KEYSTONE XL PIPELINE PROJECT - STEELE CITY SEGMENT PIPELINE ROUTE VARIATION FORM			
1	<b>VARIATION TYPE:</b> Refinement: <input type="text"/> Reroute: <input checked="" type="checkbox"/>		
	Centerline: <input checked="" type="checkbox"/>	Valve Site: <input type="text"/>	Pump Station: <input type="text"/>
2	<b>LOCATION:</b> Sketch: <input type="text"/> Attached <input type="text"/> Pictures: <input type="text"/> N/A		
	State: <input type="text"/> SD	County: <input type="text"/> Haakon	Quad Map: <input type="text"/> N/A
	Township: <input type="text"/> 01N	Range: <input type="text"/> 25E	Aerial Map: <input type="text"/> See attached map sheet
	Section: <input type="text"/> 4	Centerline: <input type="text"/> 9/21/2011	MP: <input type="text"/> 482.96 to <input type="text"/> 483.24
3	<b>REASON FOR ROUTE VARIATION</b> (Please include reason for route variation):		
	Tweak based on Civil survey data of implemented RV-0215-03 on 8/14/11 CL to distance CL away from drop off.  This reroute is proposed by engineering based on civil survey data.

**KEYSTONE XL PIPELINE PROJECT - STEELE CITY SEGMENT  
PIPELINE ROUTE VARIATION FORM**

KEYSTONE PIPELINE PROJECT - U.S. PHASE IV (STEELE CITY SEGMENT)

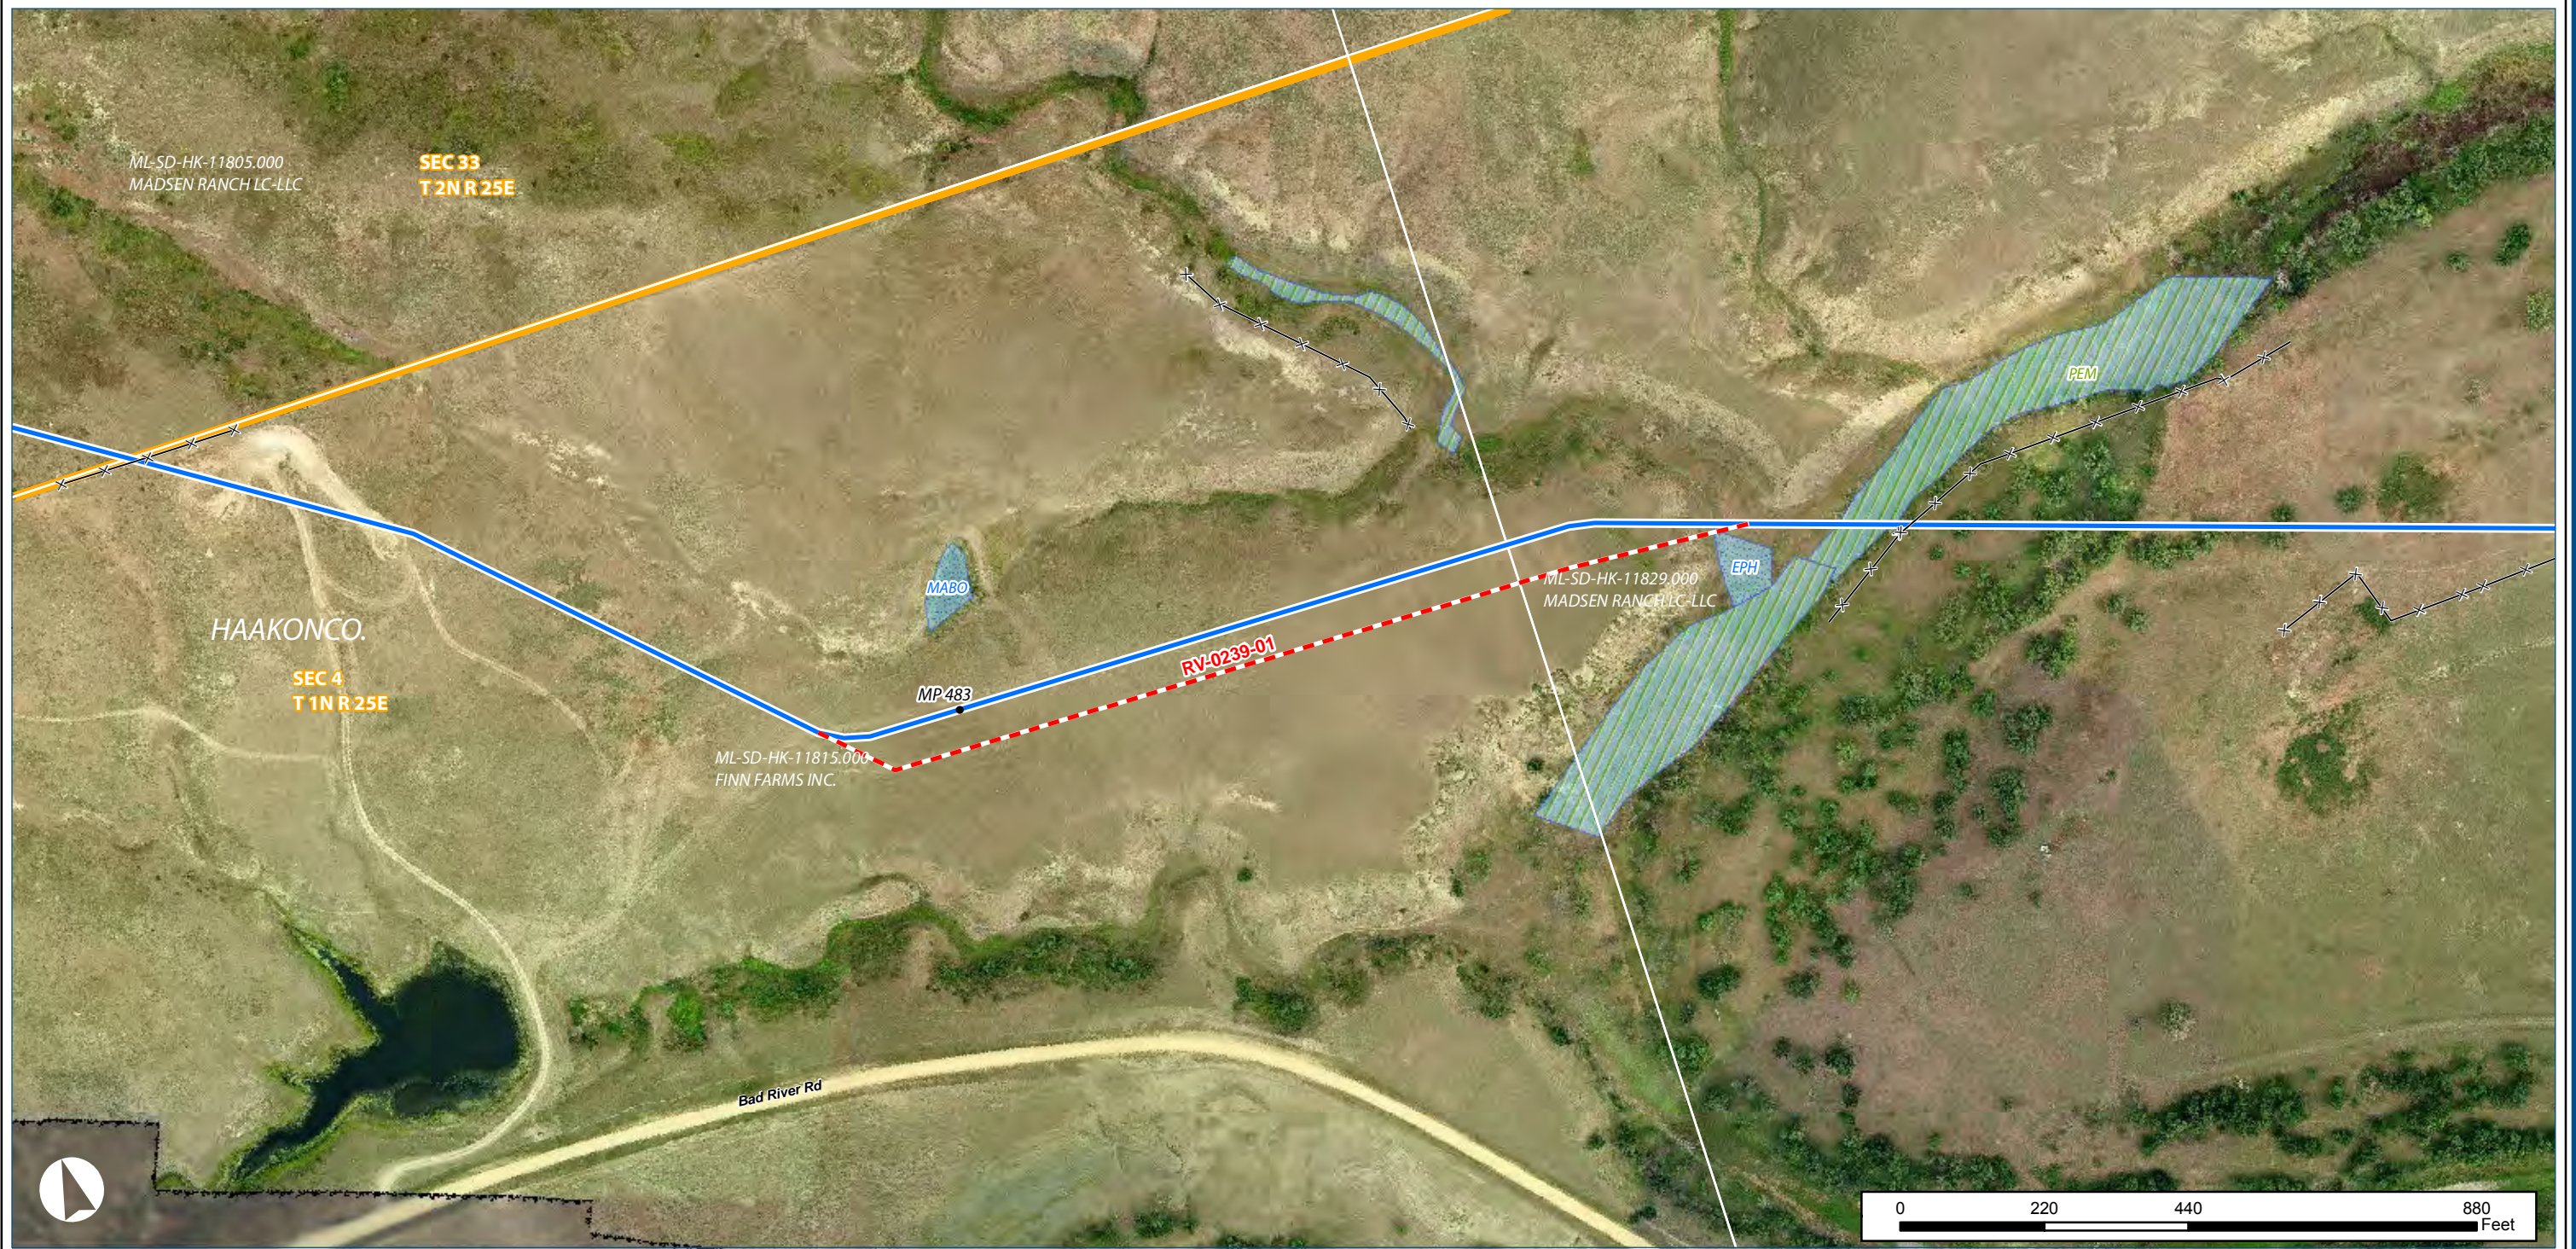
<b>DETAIL ROUTE VARIATION</b> (Please describe route variation in detail):		
	The proposed route variation starts at MP 483 and deviates ~14.5° southeast of current centerline and parallels RV-0215-03 for a total of ~1,483 ft where it rejoins the CL near MP 483.2.		
	<b>ADDITIONAL IMPACTS</b> (Please include any additional impacts which may affect cost; crossings, induction bends, etc.):		
	The proposed reroute is ~18 ft longer than the current route. The reroute does not affect a new landowner. Reroute avoids a drop off, estimated cost savings \$6,000.00		
	Is there an increase/decrease in the number of crossings? Yes <input type="text"/> No <input checked="" type="checkbox"/>		
	If yes, please list: <input type="text"/>		
	<b>COST ANALYSIS</b> (costs incurred or saved from the route variation)		
	Additional length of route realignment:	<input type="text"/> 18 ft.	\$ 6,633.77 \$ 360/ft
	Additional length of side-hill construction:	<input type="text"/> ft.	\$ - \$ 19/ft
